AP1000 CONTAINMENT VESSEL EXTERNAL PRESSURE ANALYSIS AND DESIGN

PROPOSED DESIGN CHANGE

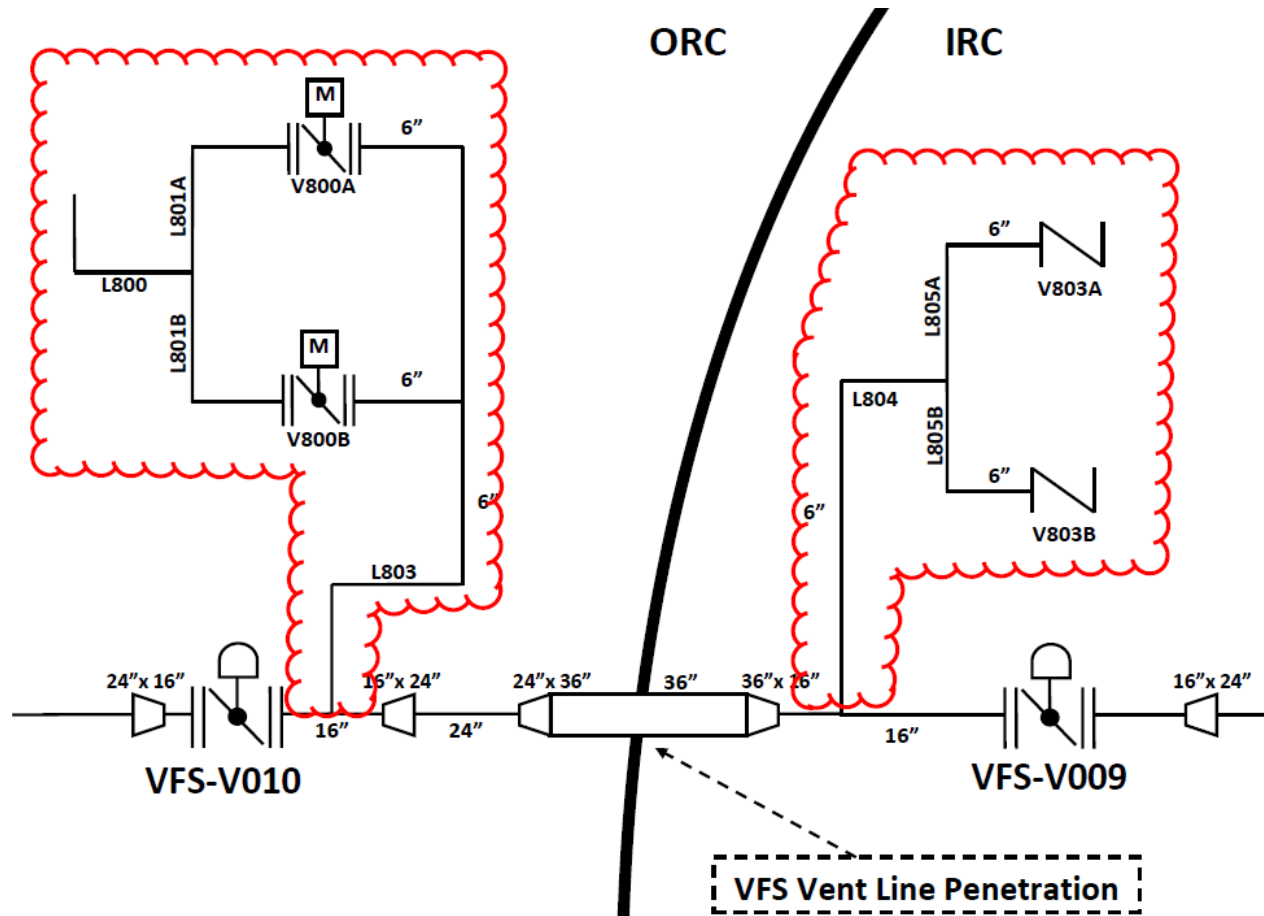
- Vacuum relief is required based on 6.2.1.1.4 containment external pressure analysis
- Current AP1000 Containment has no provision for containment vacuum relief
- Design change is being developed to resolve this issue

SIZING CONSIDERATIONS

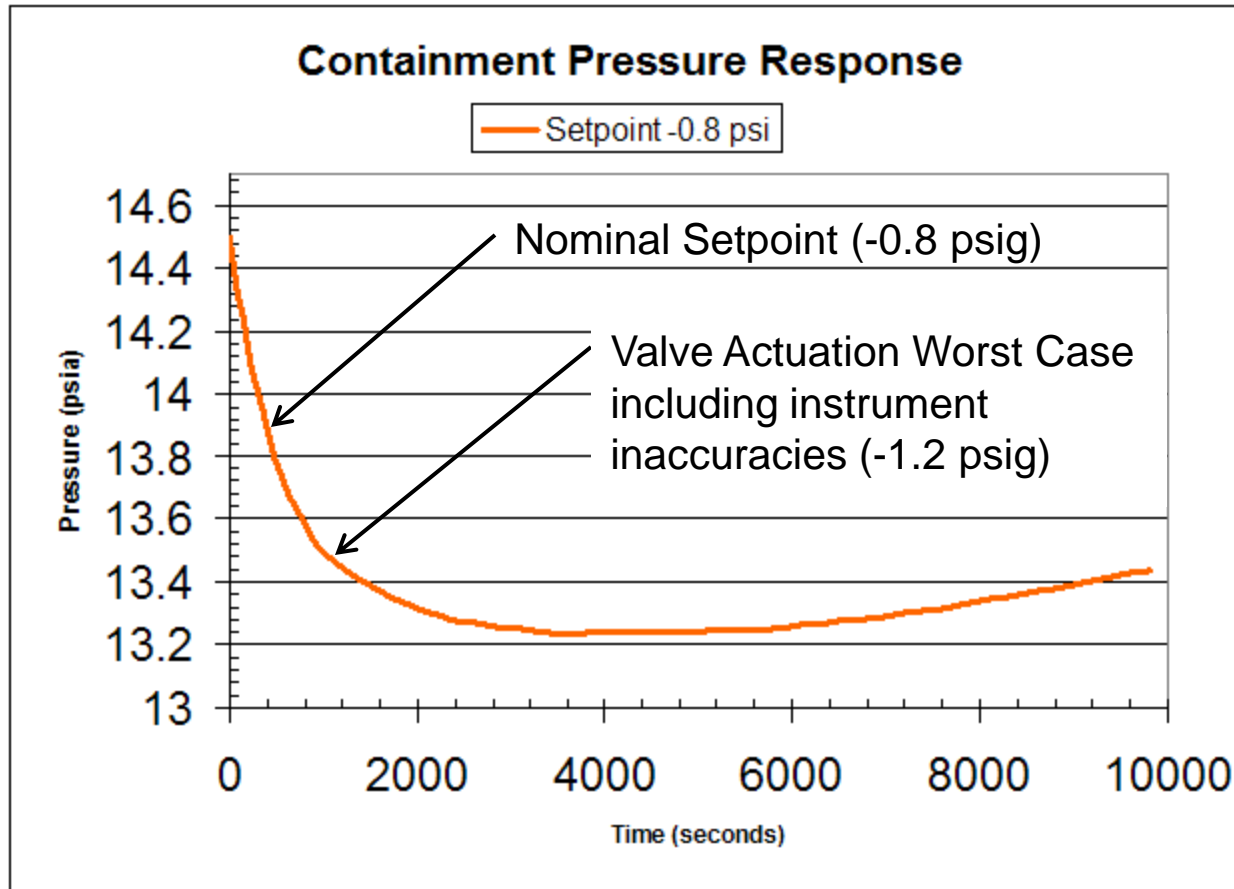
- 6" System based on the following:
 - Revised transient analysis results
 - -0.8 psig setpoint
 - ± 0.4 psi instrument accuracy for pressure measurement
 - Valve opening time (20 secs)
 - Mitigates the transient and supports the -1.7 psig containment vessel design external pressure
- Includes significant margin in hydraulic resistance
